Service Bulletin

Subject: UHCTHD Communication/Configuration Errors

Models: McDonald's UHCTHD Touch Screen Holding Cabinets

9.23.24

Figure 6

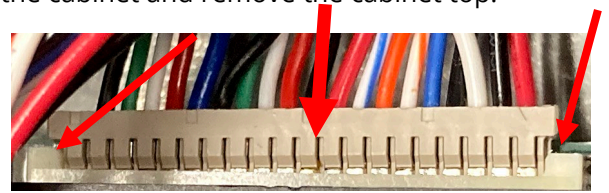
2. **Ensure the connector, that attaches directly to the rear of the touch screen, is fully inserted into the connector by pressing in on both sides of the connector (see Figure 6). The photo shown shows the right side slightly out of the connector. It may require disconnecting and reconnecting the connector. Both sides of the connector should be flush against the connector on the board.**

Figure 1

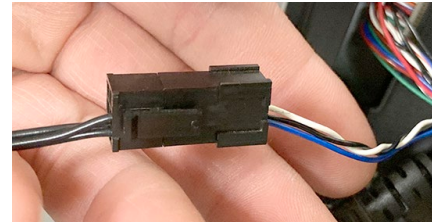
- 2) If the CAN connections between the rear touch screen and the front touch screen 6-pin blue and white wires (see Figure 1) have been disconnected and reconnected, and no pins on any of the connections have been pushed out of the connections then proceed.

Figure 3

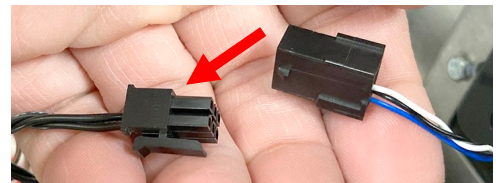
- 3) Remove the top cover of the cabinet by removing the four (4) Phillips head screws that attach the cover (see Figure 2).
- 4) With the cabinet powered up, disconnect the 6-pin CAN cable from the **REAR** controller with the black, blue and white wires. **The CAN cable MUST** be disconnected to prevent issues (see Figure 3).

Figure 4

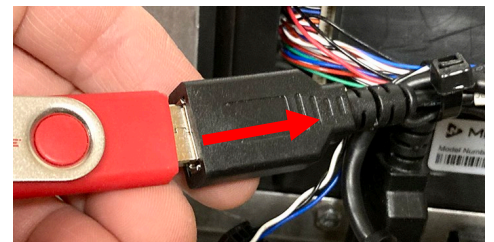
- 5) Insert the USB with **ONLY** the **vhcupdate_UHCTHD6TP_MIRROR_UX2469.tar.gz** file loaded on it into the USB port, on one of the **REAR** USB connectors of the **REAR** controller (see Figure 4). **NOTE: This file is ONLY for 6-row double sided cabinets.**
